**From:** [Alison Kennedy](#)  
**To:** [Hayley Smith](#)  
**Cc:** [Abigail Murphy](#)  
**Subject:** RE: South West Rugby Design Code  
**Date:** 27 May 2025 12:31:01  
**Attachments:** [image001.png](#)  
[image002.png](#)  
[image003.png](#)  
[image004.png](#)  
[image005.png](#)  
[image006.png](#)

**The Town and Country Planning (Local Planning) (England) Regulations 2012  
South West Rugby Design Code Supplementary Planning Document public  
consultation**

Catesby Estates' Consultation Response Table to the South West Rugby Design Code SPD (February 2025)

# Suggested Revisions to Homestead Link Road's Compound Areas

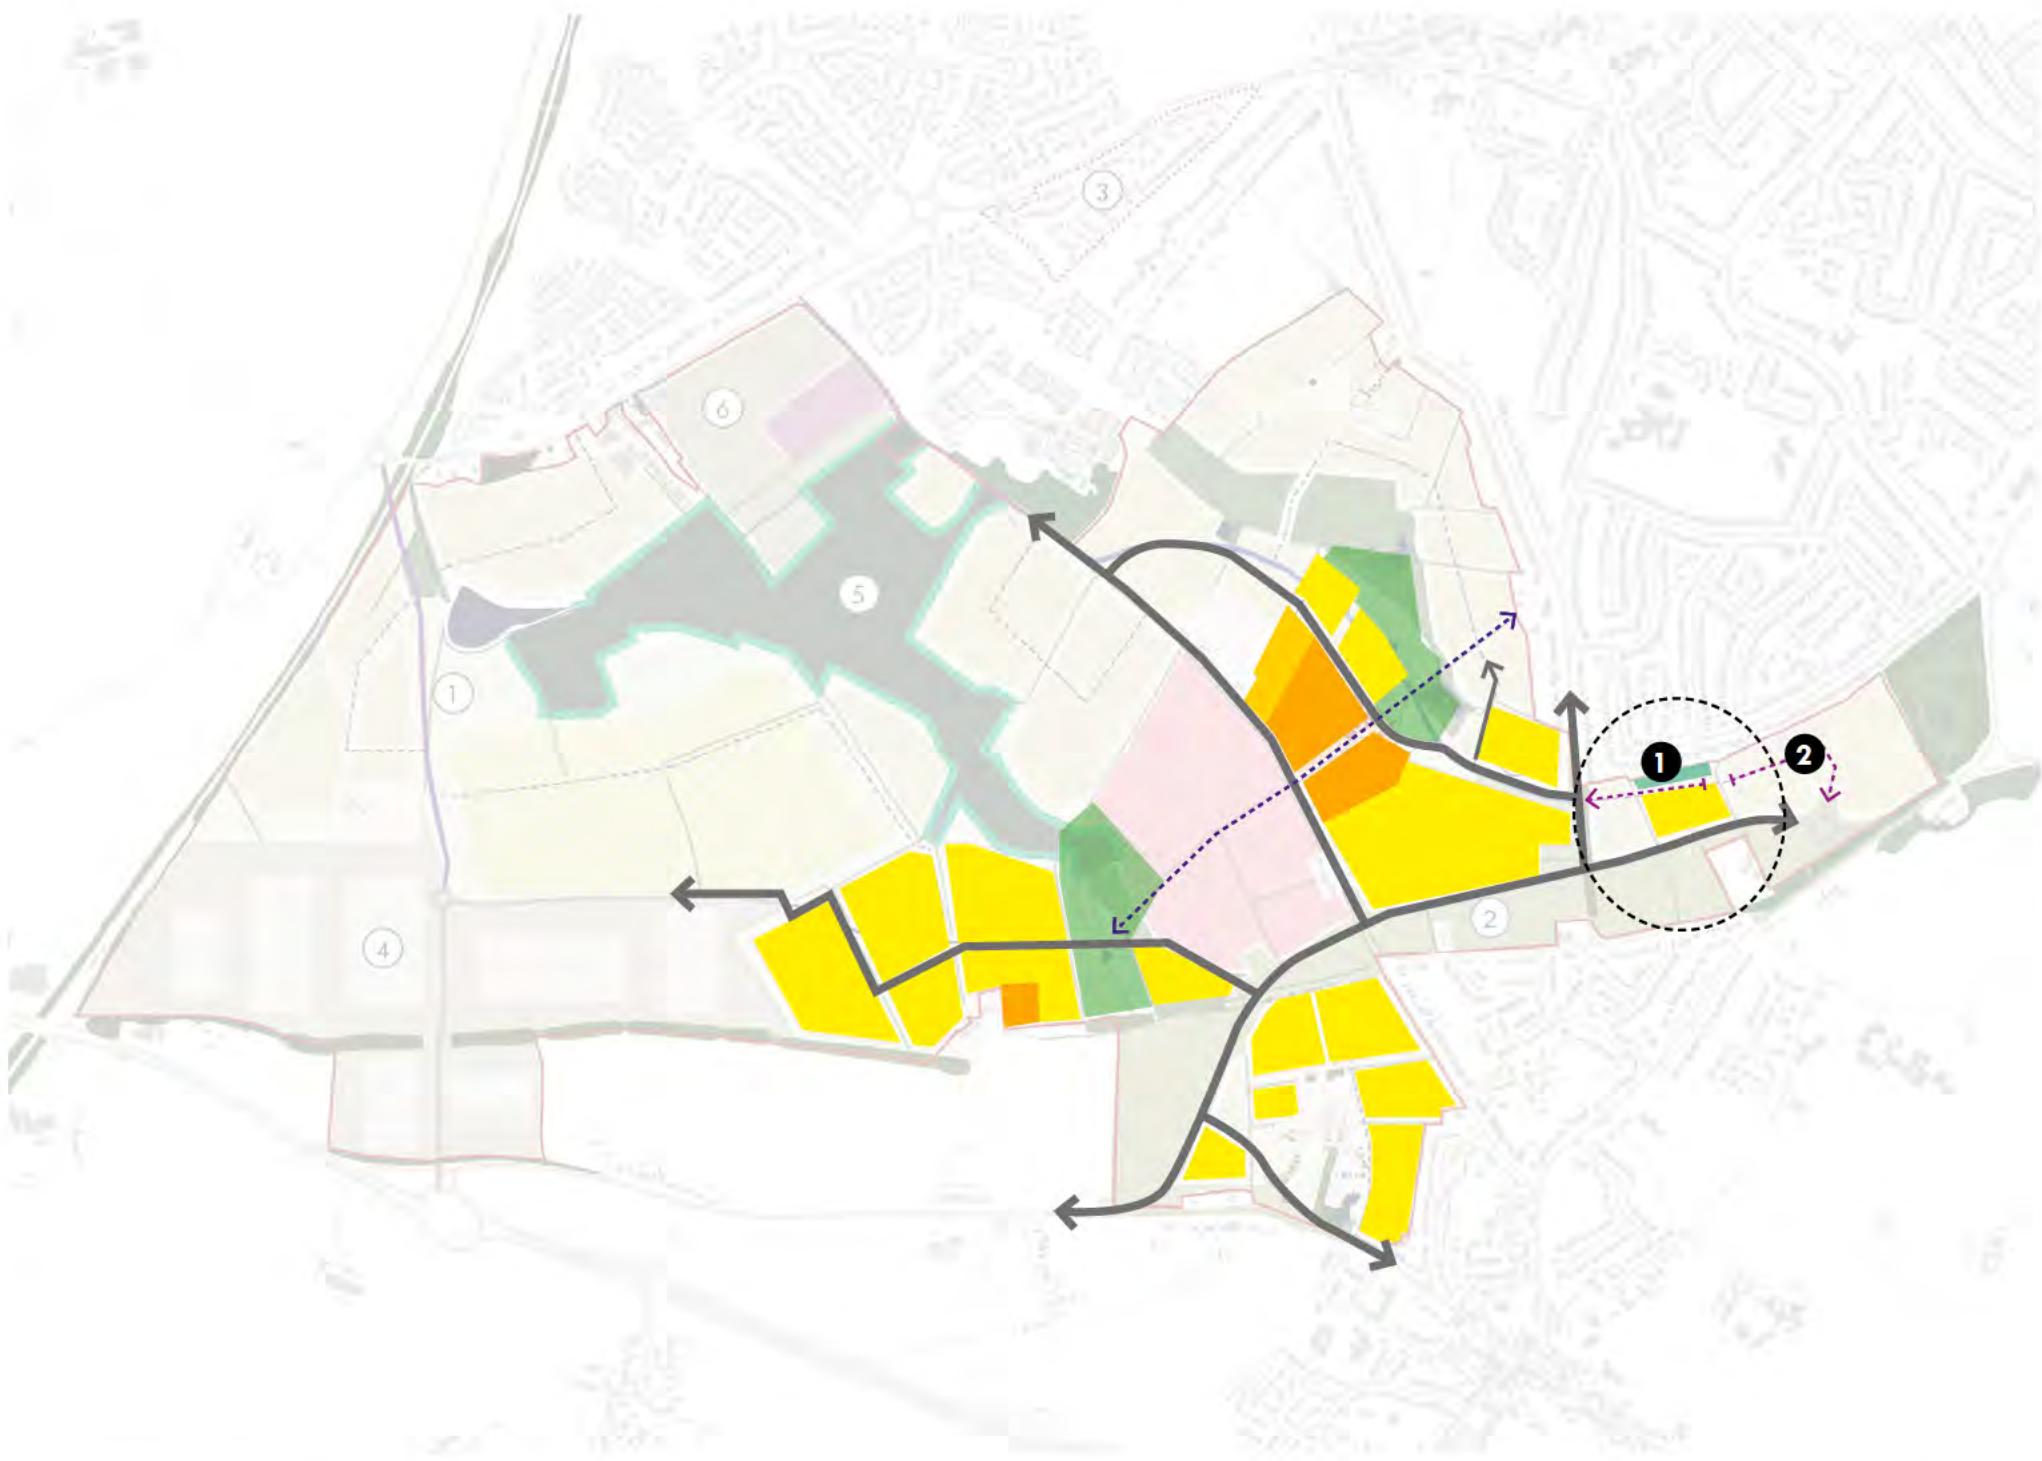
- 1** Suggest that compound areas that form a part of the Homestead Link Road's application to be removed from the permanent works extents on the Framework Masterplan. See notes on the adjacent mark-up for the anticipated use of each of the proposed areas.

# Suggested Amendments to Local Access Road in the Safeguarded Land

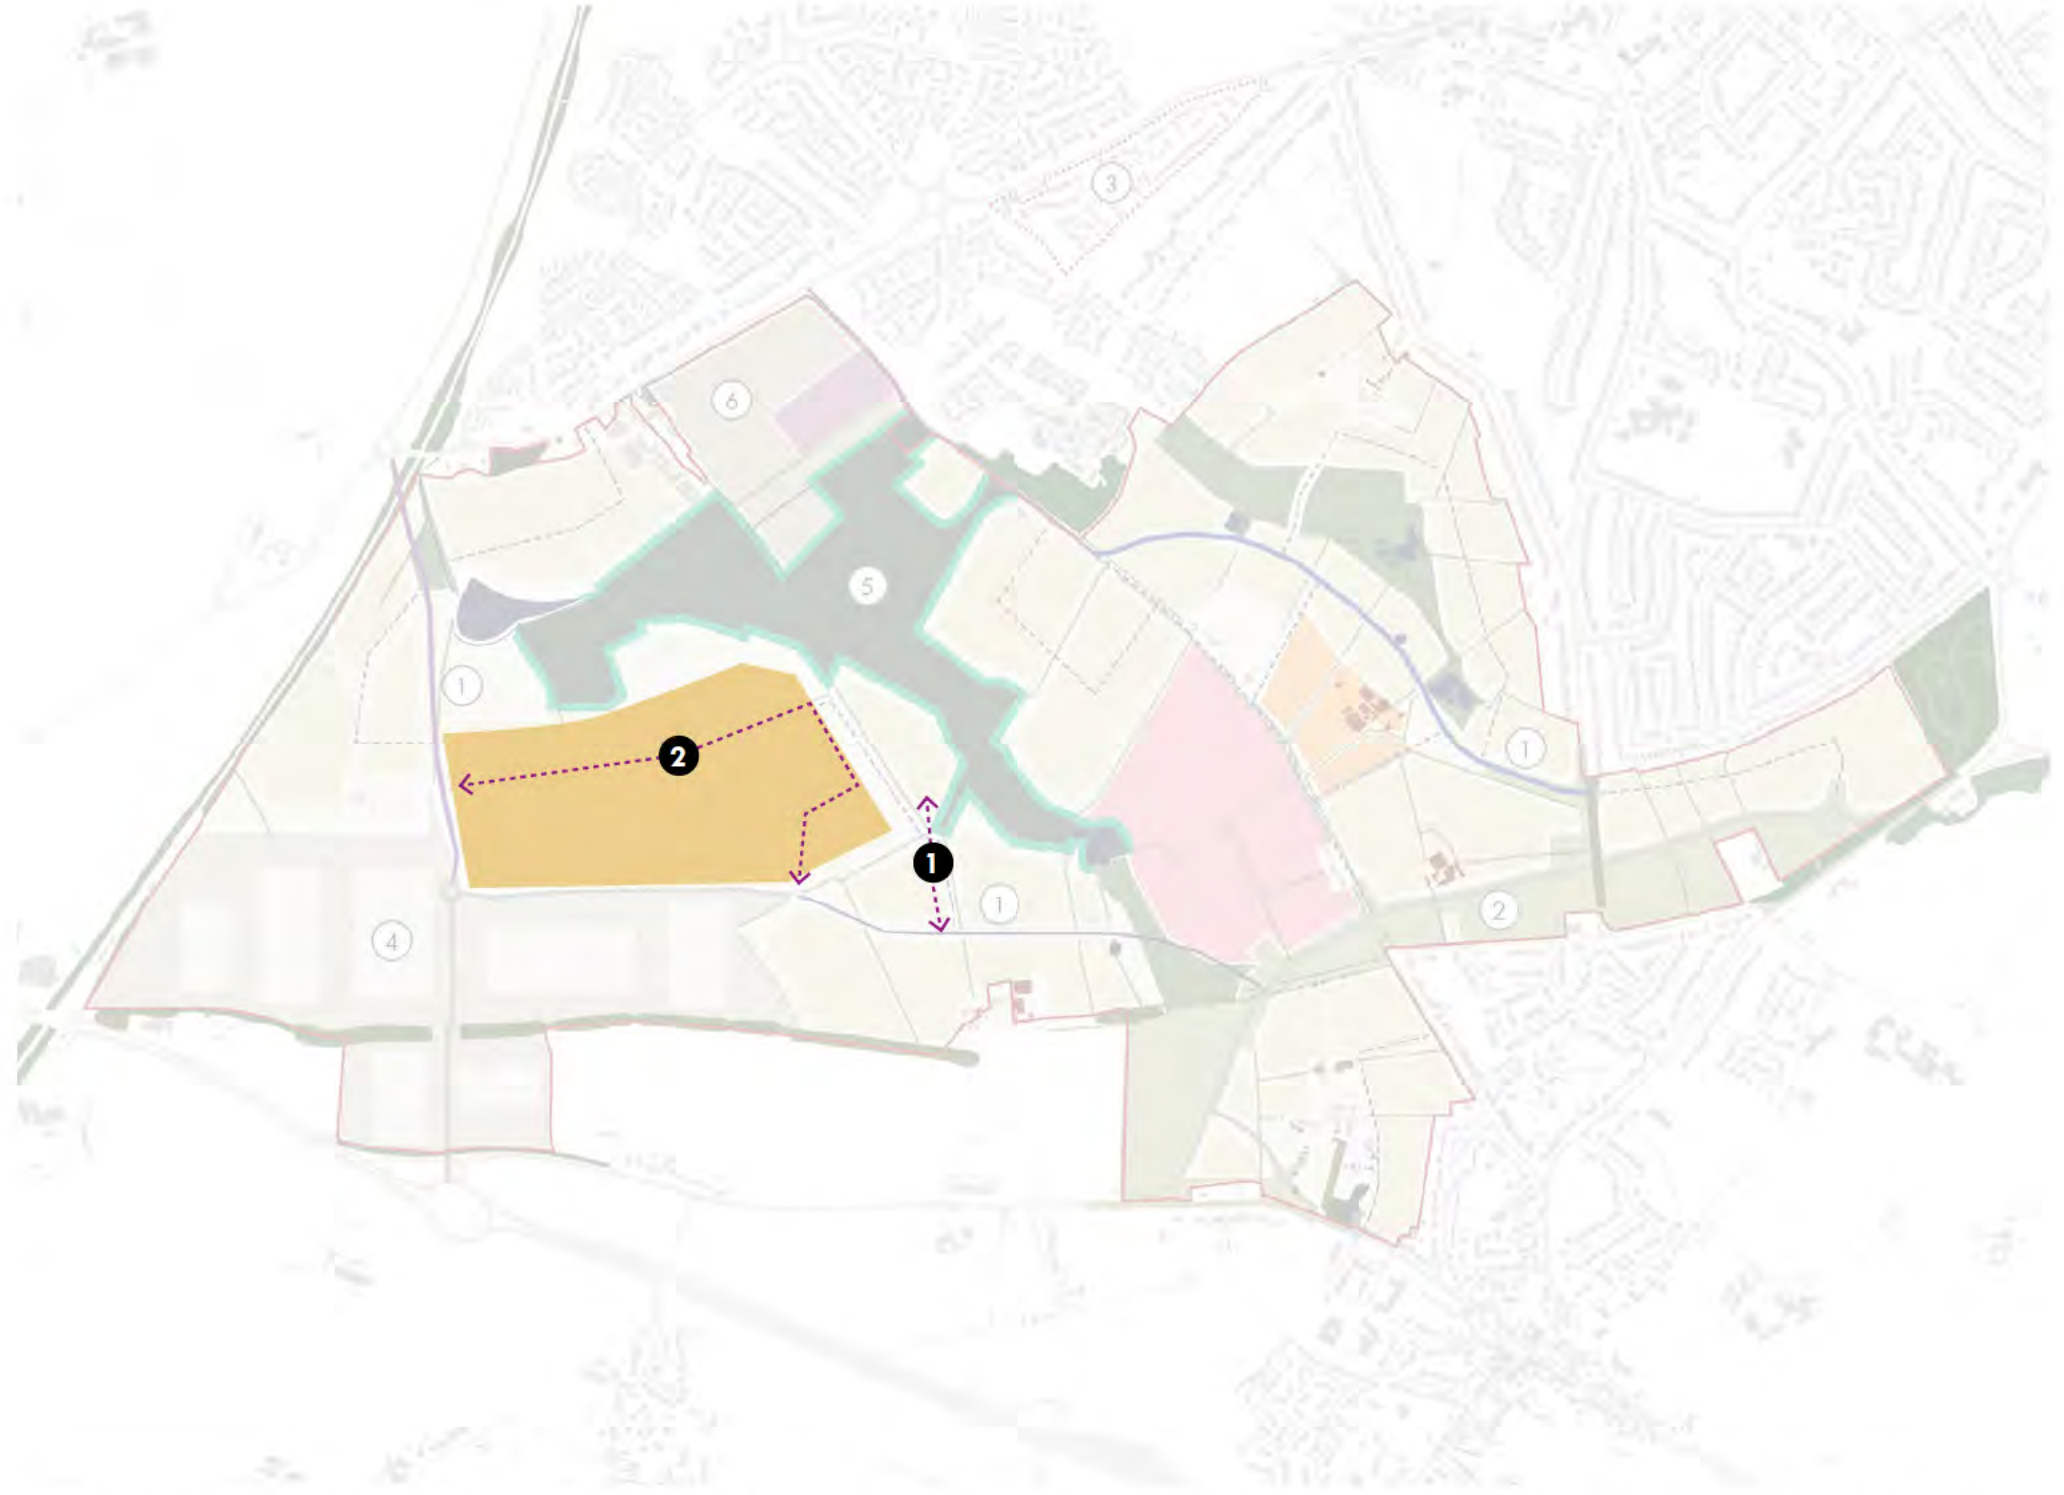
- 1** Suggest the Framework Masterplan is aligned with Home England's emerging proposals by showing an illustrative vehicular connection to the residential parcel to the north that is not but not connected to the Safeguarded Land to the west.

We are very concerned by the fact that the Local Access Road appears to imply a vehicular link between the Safeguard Land and Homes England's land. We are concerned that if the safeguarded land becomes employment this road would undermine the allocation's current transport strategy and the bus gate on the Sustainable Transport Link.

- 2** Suggest amendments to the indicative access arrangements for the Safeguarded Land are made to address our comments above and access is provided from the west.

# Suggested Amendment to Buffer Along Cawston Spinney

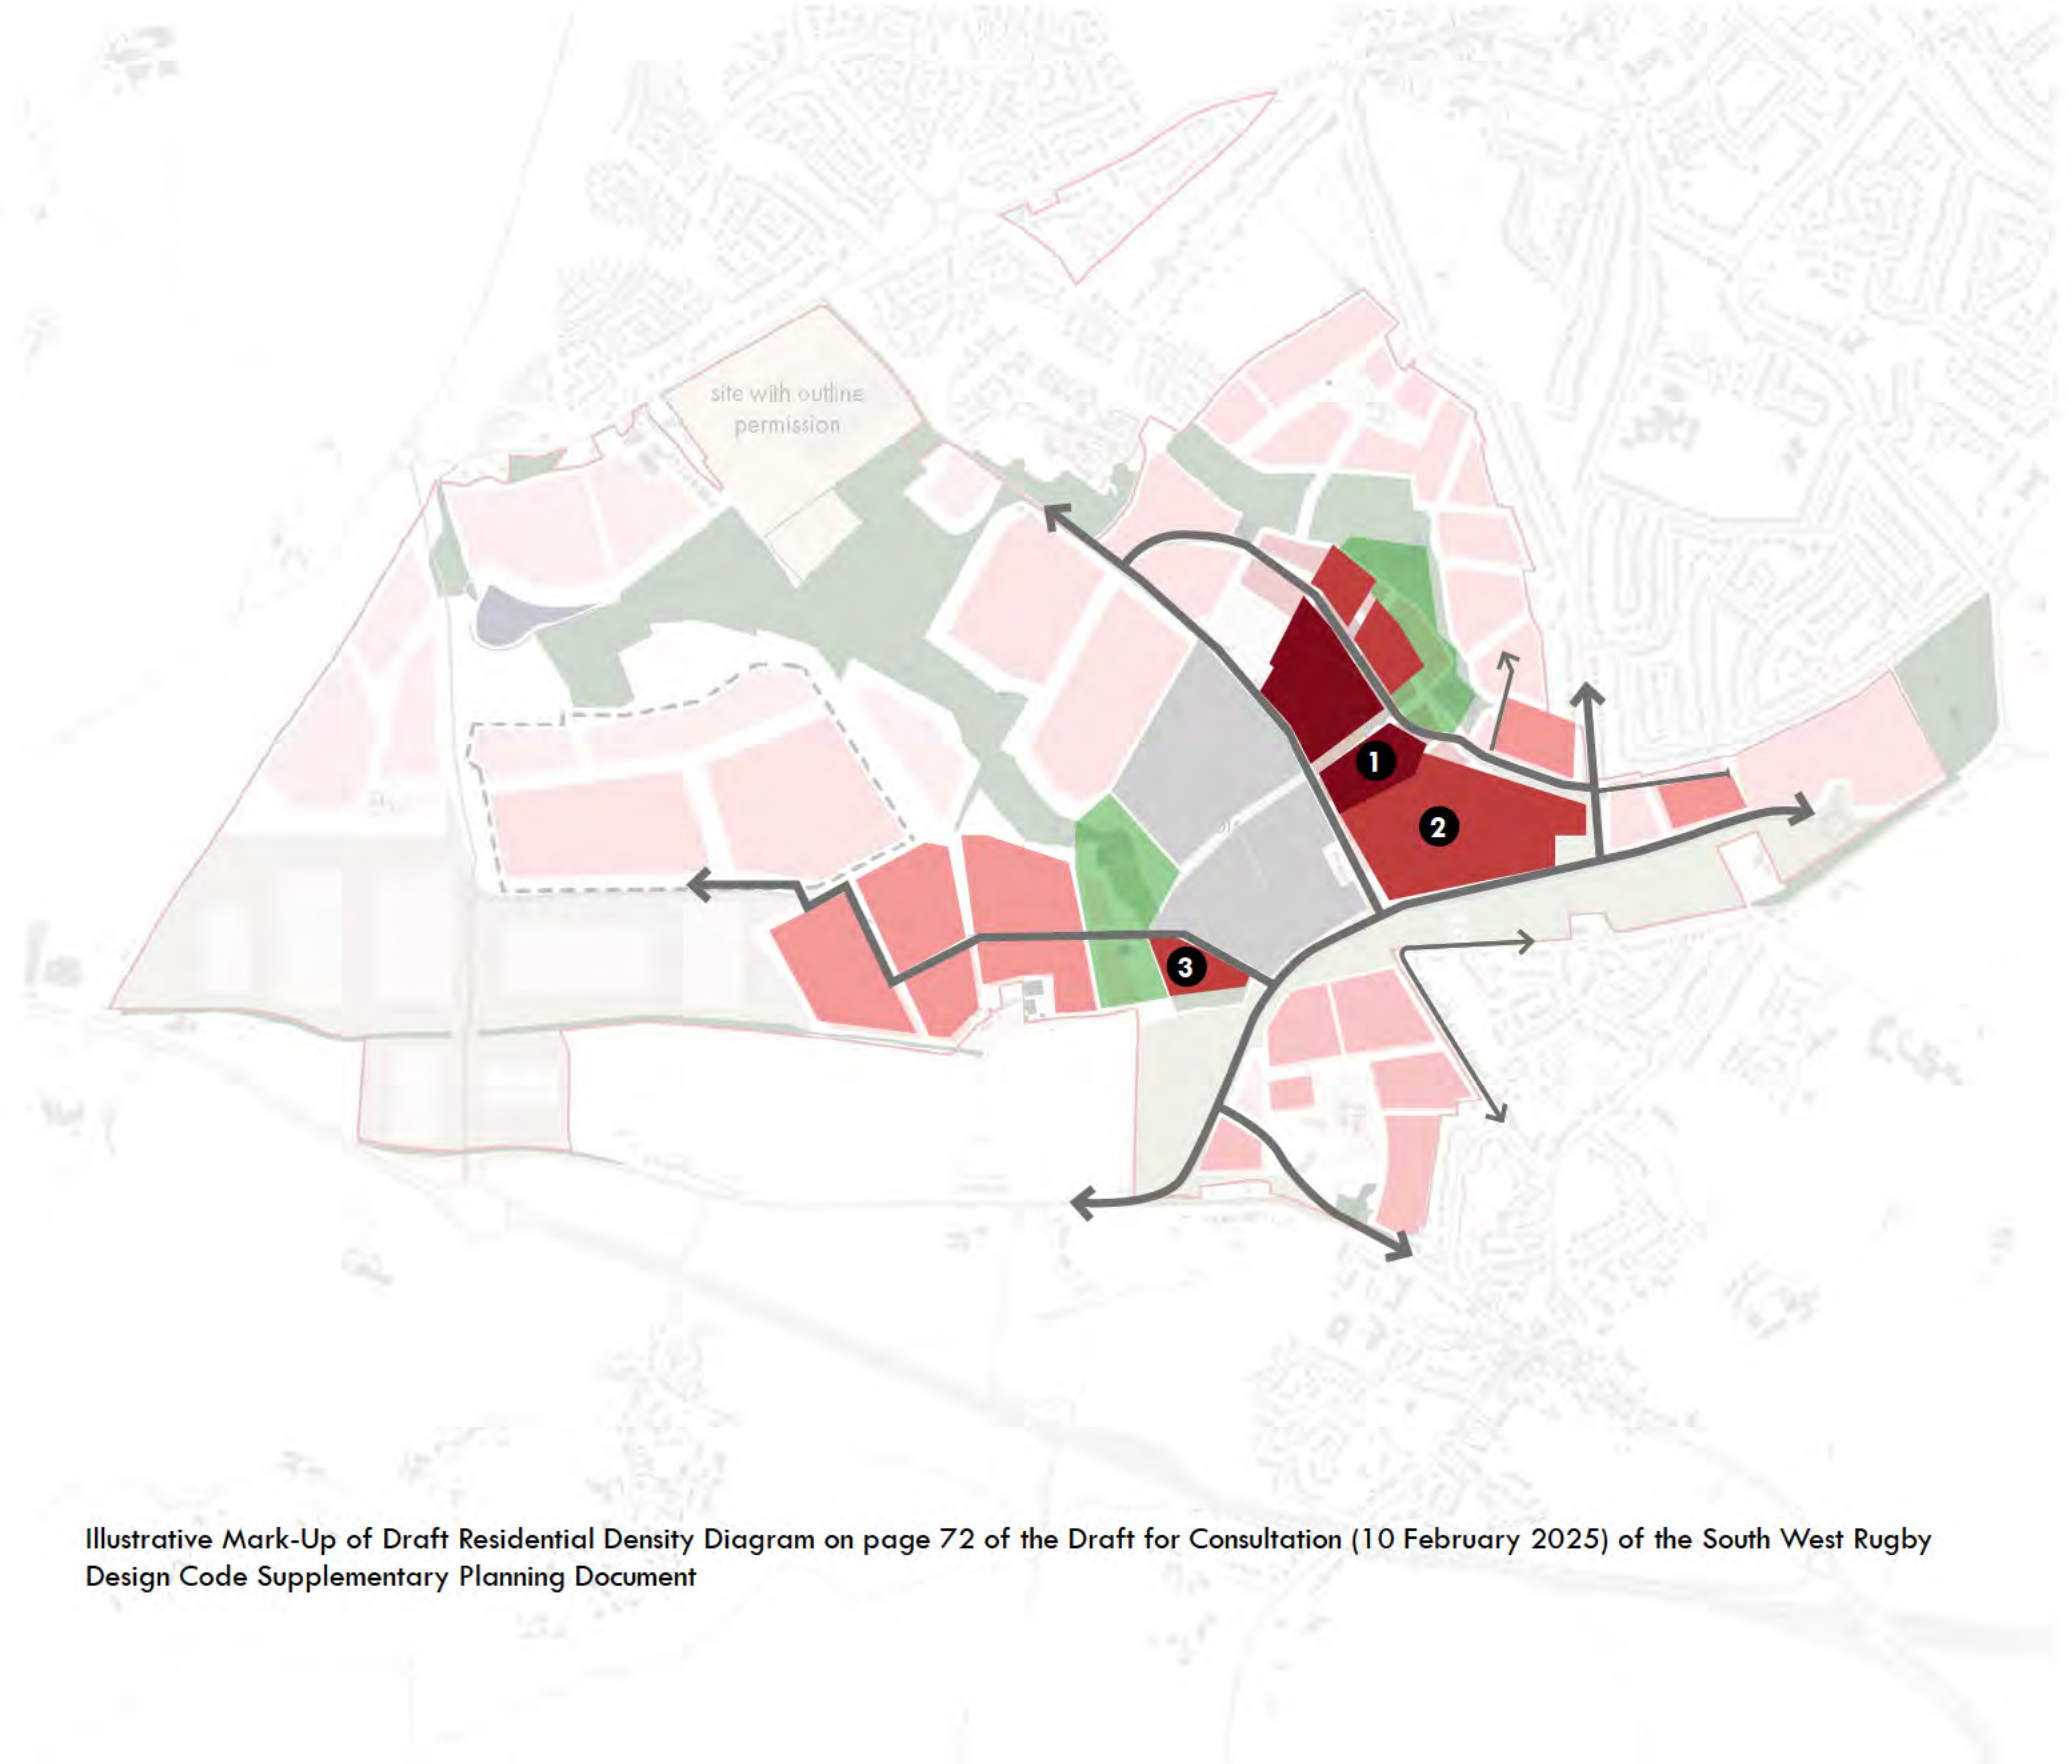
- 1** Suggest the buffer to Cawston Spinney is removed or further clarified as indicative in regards to the Framework Masterplan. See our supporting written response to the Draft Design Code.
- 2** We note Cock Robin Wood has no buffer indicated within the Framework Masterplan despite this being a Local Wildlife Site.
